Table of Contents for Robertson Hill
Heritage Tree Variance Package

PROJECT NAME: Robertson Hill Multifamily Development

TREE PERMIT: 10597946

SUBJECT: Tree Permit for Robertson Hill Multi-Family
813 East 11th Street

RE: 813 E. 11th Street, Austin, TX **Tree # 4279**

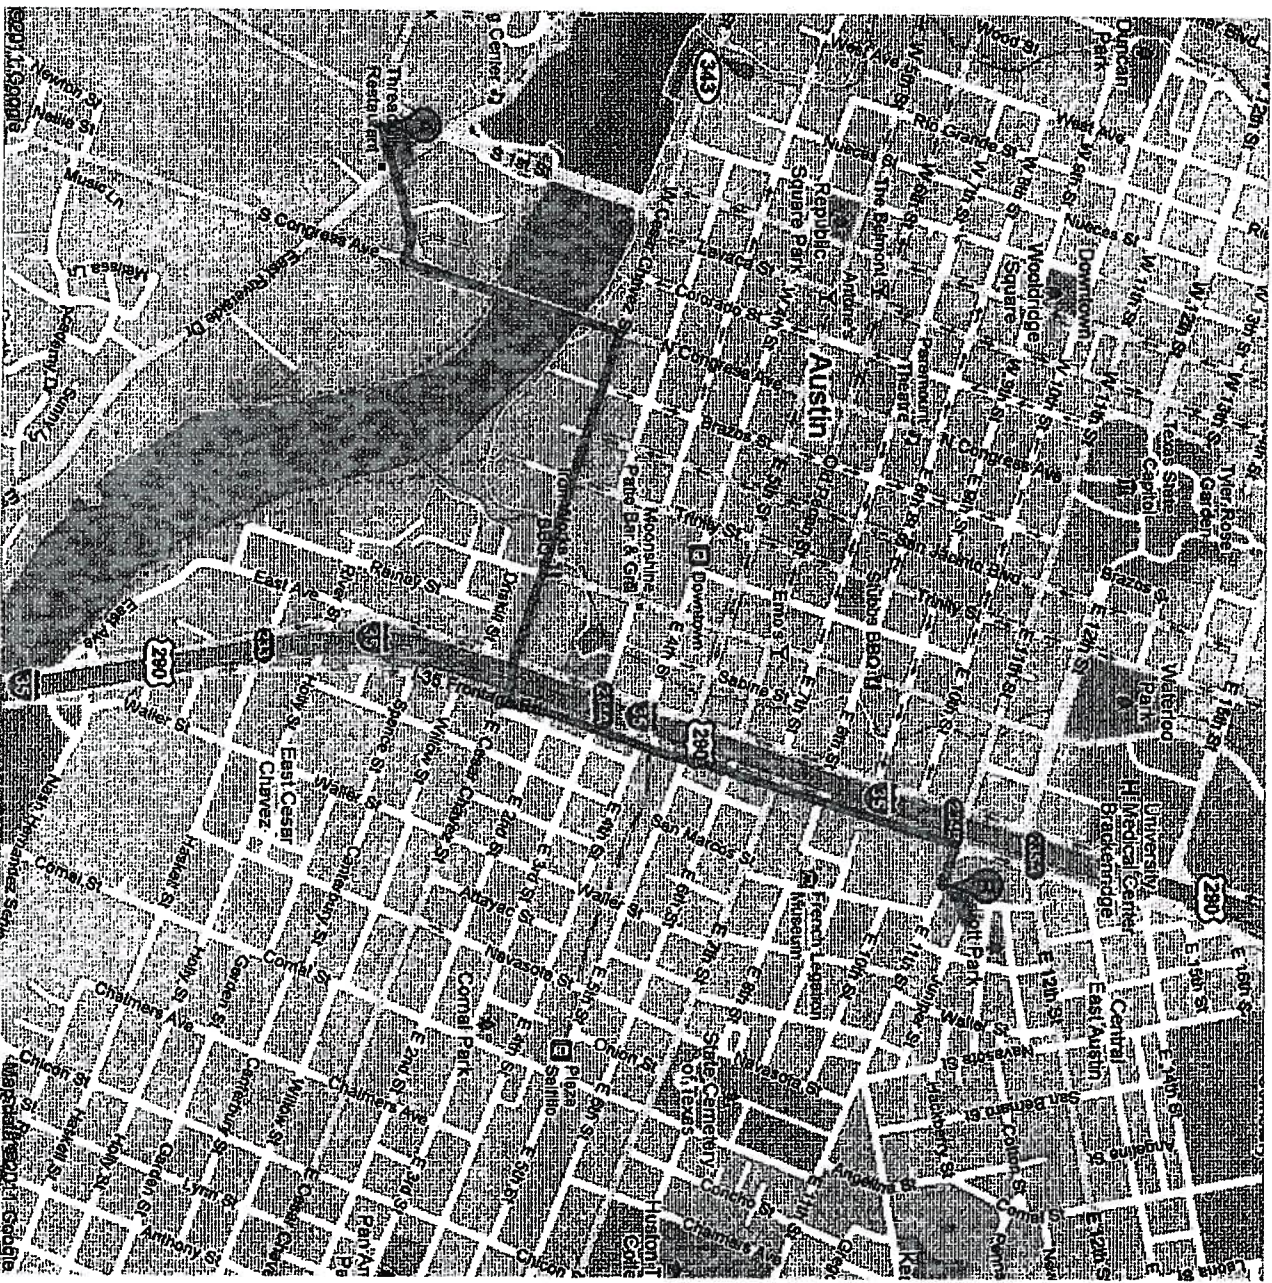
Dear Mr. Neslund,
Thanks you for the opportunity to inspect the second section of the above-mentioned property. I noted the larger 28 inch Live oak tree # 4279 has a severe cavity and freeze damage along with signs of drought stress.
See photo's below

Also notice: Die back, Cavity and Thin Canopy
